# IEEE802.3at Task Force

## Vport ad hoc Suggested Remedy for Ipeak Issues #114, #137, #227, #79

Jan 2008

Yair Darshan  
Microsemi Corporation

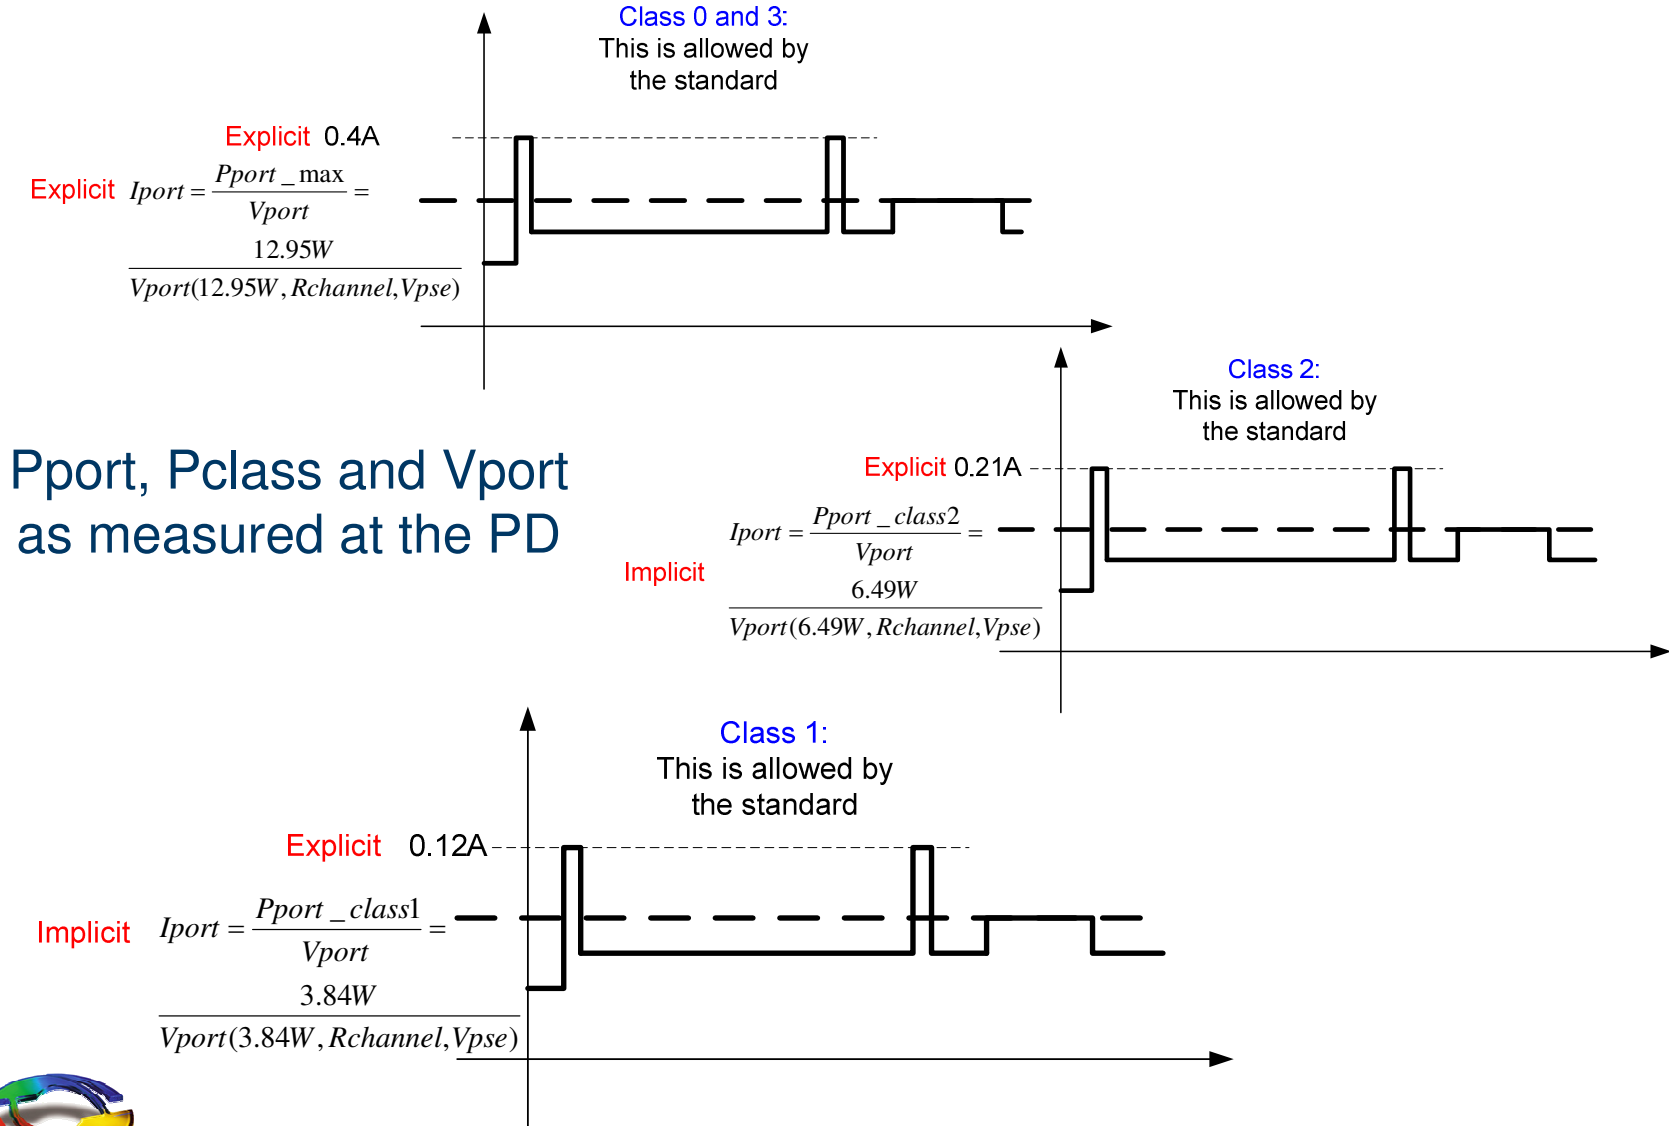
## ■ 33.3.5.4 Peak Operating Current

- At any operating condition the peak current shall not exceed  $P_{Port\_max}/V_{Port}$  for more than 50ms max and 5% duty cycle max. Peak current shall not exceed  $I_{Portpk}$  max.

See Drawings Next Slide
